Product Change Notification / SYST-08HQLN222

Document Change

ERRATA - PIC32MZ Embedded Connectivity with Floating Point Unit (EF) Family Silicon Errata and Data Sheet Clarification

PIC32MZ Embedded Connectivity with Floating Point Unit (EF) Family Silicon Errata and Data Sheet Clarification

FIGURE 1: Posc CRYSTAL CIRCUIT

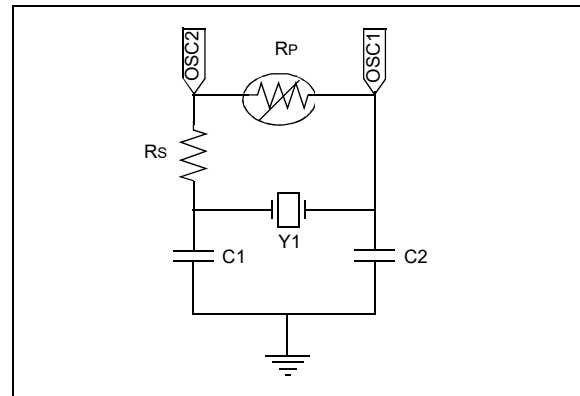
Revision A1 Silicon: A crystal oscillator cannot be used as an input to the Primary Oscillator (Posc) pins OSC1 and OSC2.

Revision A3 and B2 Silicon: The Posc has been tested in a normal power-up sequence and supports specific crystal operation.

The Primary Oscillator (Posc) has been characterized to operate at 8 MHz, 12 MHz, and 24 MHz when the circuit in [Figure 1](#) is implemented, and the operating conditions listed in [Table 3](#) are met.

Silicon Work around 1

TABLE 3: CRYSTAL SPECIFICATIONS

Crystal Frequency (see Note 1)	Series Resistor (Rs)	Posc Gain Setting POSCGAIN<1:0> (DEVCFG0<20:19>)	Posc Boost Setting POSCBOOST (DEVCFG0<21>)
8 MHz	2 kΩ	'0b00 (GAIN_0)	'0b1 (ON)
12 MHz	1 kΩ	'0b00 (GAIN_0)	'0b1 (ON)
24 MHz	0 kΩ	'0b00 (GAIN_0)	'0b1 (ON)

- Note 1:** Using any other crystal frequency will require special component selection and characterization.
Note 2: A parallel resistor (Rp) should not be used to increase the gain of the POSC.

64-PIN QFN⁽⁴⁾ AND TQFP (TOP VIEW)

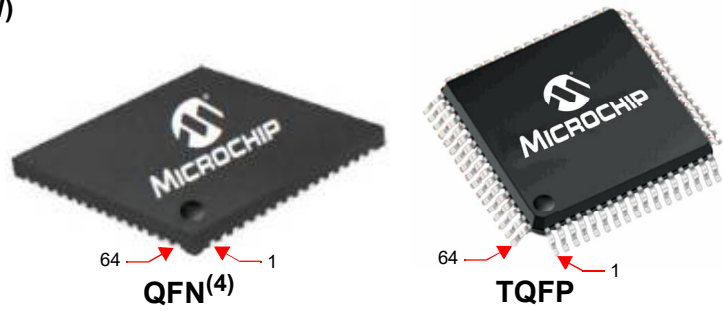
In Table 2. “Pin Names for 64-pin QFN and TQFP Devices” of the current data sheet, the AECRS_{DV} signal was erroneously omitted from the pin number 44 and added to the pin number 62. The correct assignment is shown in bold type in the following table.
